# Access Compliance Report

## Public Rights-of-Way

### (Curb Ramps)

Intersection ID: 48140	Main Street: MCCAMEY_DR	Cross Street: BUTTERBURR_DR	Location: SE
ADA ID: C47CAD7F2377	Ramp Type: PerpDiag	Initial Pass/Fail: Fail	Overall Compliance: No
Severity Score: 8.75			
Codes/Mitigation Info/Possible Solution		Field Measurements/Component Compliance

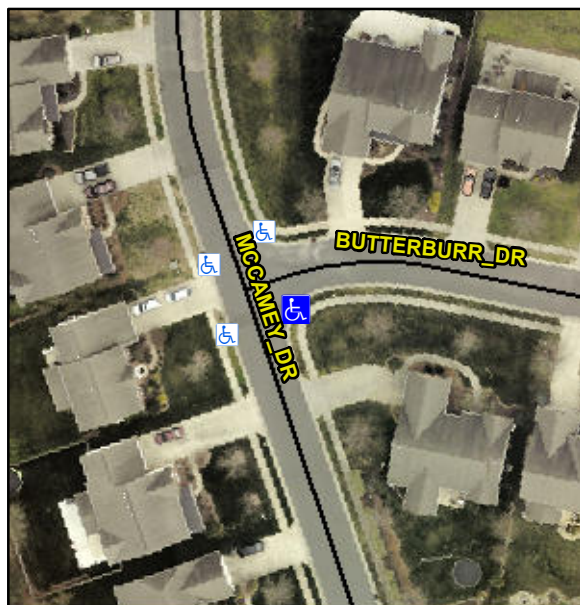
**Not Found, R304.5.1**

Compliance	Description	Data	Compliance	Description	Data
N/A	Ramp Length (in)	48.0	Yes	Ramp Slope (%)	5.2
No	Ramp Width (in)	38.0	Yes	Ramp XSlope (%)	0.3
N/A	Flare Type LT	N/A	N/A	Flare Type RT	N/A
N/A	Flare Slope LT (%)	N/A	N/A	Flare Slope RT (%)	N/A
N/A	Flare Traversable LT?	N/A	N/A	Flare Traversable RT?	N/A
N/A	Landing Length (in)	N/A	N/A	DWS Provided?	N/A
N/A	Landing Width (in)	N/A	N/A	DWS Contrast?	N/A
N/A	Landing Slope (%)	N/A	N/A	DWS Length (in)	N/A
N/A	Landing X Slope (%)	N/A	N/A	DWS Full Width?	N/A
N/A	Landing Curb? (Y/N)	N/A	N/A	DWS Offset (in)	N/A
N/A	Shared Landing?	N/A			
N/A	Gutter Ponding?	N/A	N/A	Gutter Slope (%)	N/A
N/A	Gutter Lip Ht (in)	N/A	N/A	Gutter X Slope (%)	N/A
N/A	Painted X Walk1?	No	N/A	Painted X Walk2?	No
	X Walk 1 Direction	To N		X Walk 2 Direction	To W
N/A	X Walk 1 Width (in)	N/A	N/A	X Walk 2 Width (in)	N/A
	X Walk 1 Slope (%)	3.6		X Walk 2 Slope (%)	2.2
	X Walk 1 X Slope (%)	1.1		X Walk 2 X Slope (%)	1.5

**Remove & Replace Curb Ramp With Two New Directional Ramps or Equivalent.**
